Technical Bulletin

F-Series Paper Roll Clamp Cylinder Back-up Rings and Seal Service Kits 555227 & 555725

Inspect Existing Inventory of Cylinder Seal Kits 555227 and 555725

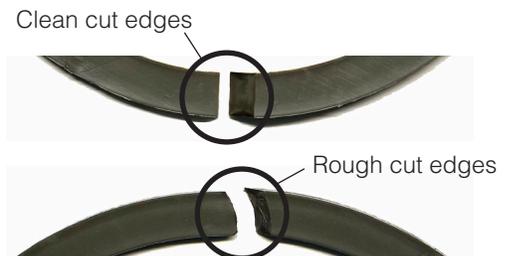
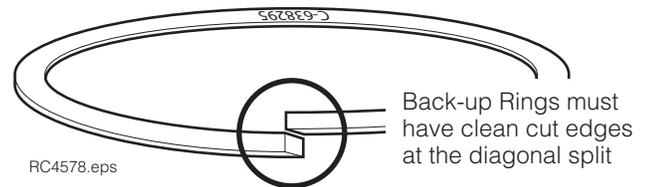
We are relying on our dealers to inspect their existing inventory of Seal Kits 555227 and 555725 with the Batch Codes listed below and to communicate with end users who may also have seal kits in inventory.

Seal Kit 555227 with Batch Code prior to 262047-0001

Seal Kit 555725 with Batch Code prior to 263179-0002

Inspect the large back-up rings in the seal kit. The part number C-638293 or C-638295 is molded into the side of the ring. The back-up rings must have clean cut edges on the diagonal split. Rough edges on the split surfaces may cut the piston pressure seal surface, resulting in the leak down of clamping pressure.

If you identify rough cut back-up rings in a kit or have any question as to the condition of the ring, contact Cascade to arrange returning the seal kit to the Cascade Parts Depot for an exchange kit. See contacts on front of this document.

Method A – Cylinder Pressure Test Using Gauges

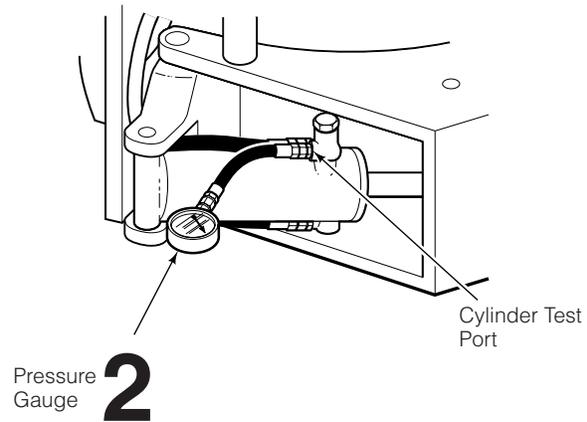
3 Position both arms at mid stroke to relieve cylinder pressure. Remove, swap and reinstall the cylinder check valve cartridges.

- If the gauge pressure on the cylinder continues to drop more than 150 psi (10 bar) initially, and additional drop exceeds 25 psi (2 bar) per minute, the cylinder piston seals are faulty. Refer to Service Manual 674512 for cylinder service.
- If the gauge pressure on the cylinder does not drop more than 150 psi (10 bar) initially, and additional drop does not exceed 25 psi (2 bar) per minute, the check valve (now in the other cylinder) is faulty and requires replacement.

Method B – Measure Clamp Force Retention using a Clamp Force Indicator

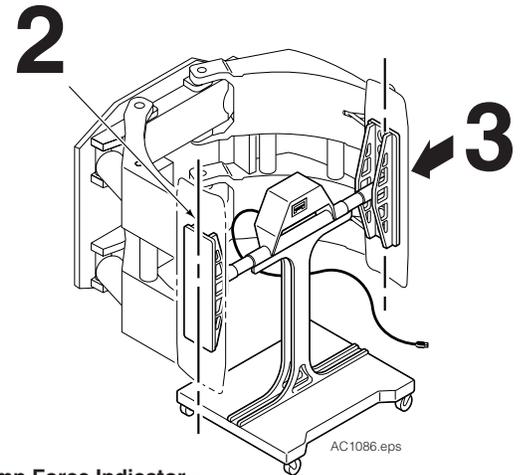
- 2 **Make sure both arms are not at the end of stroke when clamped on the Indicator.** Position the Clamp Force Indicator solidly against the short arm contact pad. Center pad surfaces vertically and horizontally.
- 3 Slowly clamp the long arm pad against the indicator pad. Clamp fully at 2/3rd throttle, holding the CLAMP lever several seconds. Release and record the initial display value. **Determine if this value is correct and does not exceed clamp force recommended for rolls being handled.**

- If the indicator pressures drops more than 150 psi (10 bar) initially and an additional drop exceeds 25 psi (2 bar) per minute, the cylinder check valve cartridges or piston seals may be faulty. Continue troubleshooting using Service Manual 674512.
- If the cylinder seals are isolated as needing service, rebuild the cylinder using a seal kit that has had the back-up rings inspected. See Action item 1 for inspection,
